# Access Compliance Report

## Public Rights-of-Way

Intersection ID: 19259	Main Street: PEBBLESTONE_DR	Cross Street: VILLAGE_LAKE_DR	Location: NW
ADA ID: 6DB03D09EE27	Ramp Type: PerpDiag	Initial Pass/Fail: Fail	Overall Compliance: No
			Severity Score: 13.75

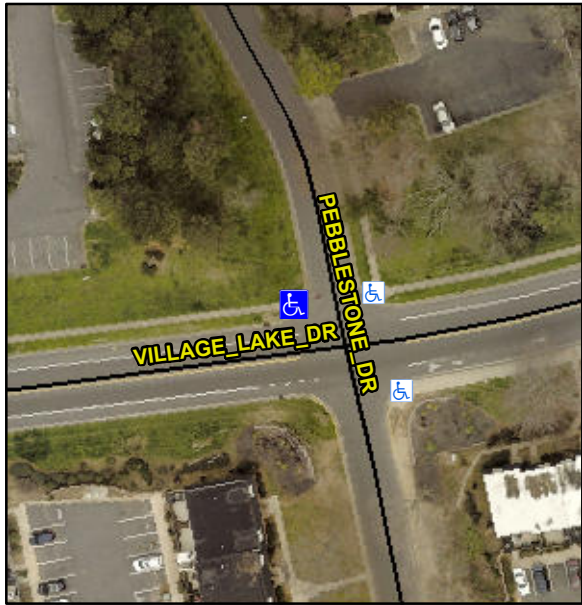
Codes/Mitigation Info/Possible Solution		Field Measurements/Component Compliance						
	Possible Solutions:	<b>Compliance</b>	<b>Description</b>	<b>Data</b>	<b>Compliance</b>	<b>Description</b>	<b>Data</b>	
	<b>Remove &amp; Replace Curb Ramp With Two New Directional Ramps or Equivalent.</b>	N/A	Ramp Length (in)	39.0	No	Ramp Slope (%)	9.5	
		Yes	Ramp Width (in)	48.0	No	Ramp XSlope (%)	2.1	
		N/A	Flare Type LT	N/A	N/A	Flare Type RT	N/A	
		N/A	Flare Slope LT (%)	N/A	N/A	Flare Slope RT (%)	N/A	
		N/A	Flare Traversable LT?	N/A	N/A	Flare Traversable RT?	N/A	
		N/A	Landing Length (in)	N/A	N/A	DWS Provided?	N/A	
		N/A	Landing Width (in)	N/A	N/A	DWS Contrast?	N/A	
		N/A	Landing Slope (%)	N/A	N/A	DWS Length (in)	N/A	
		N/A	Landing X Slope (%)	N/A	N/A	DWS Full Width?	N/A	
Surveyor Notes:	N/A	N/A	Landing Curb? (Y/N)	N/A	N/A	DWS Offset (in)	N/A	
		N/A	Shared Landing?	N/A				
		N/A	Gutter Ponding?	N/A	N/A	Gutter Slope (%)	N/A

N/A	Gutter Lip Ht (in)	N/A	N/A	Gutter X Slope (%)	N/A	
		N/A	Painted X Walk1?	No	N/A	Painted X Walk2?	No	
			X Walk 1 Direction	To S		X Walk 2 Direction	To E	
		N/A	X Walk 1 Width (in)	N/A	N/A	X Walk 2 Width (in)	N/A	
			X Walk 1 Slope (%)	2.6		X Walk 2 Slope (%)	2.8	
			X Walk 1 X Slope (%)	2.6		X Walk 2 X Slope (%)	2.6	
	PROW/ADA:	Not Found, R304.2.2, R304.5.3	N/A	Ramp inside XWalk1?	N/A	N/A	Ramp inside XWalk2?	N/A
			Road Slope (%)	2.5	N/A	Clear Space?	N/A	
			Road X Slope (%)	3.0	N/A	Clear Space to XWalk (in)	N/A	
N/A			Any Obstructions?	N/A	N/A	Storm Grate/Utility Hazard?	N/A	
			Obstruction Type			Storm Grate/Utility Type		
					N/A		N/A	
					Yes	Surface Condition? (G/P)	Good	
Total Cost:			\$	3200.00
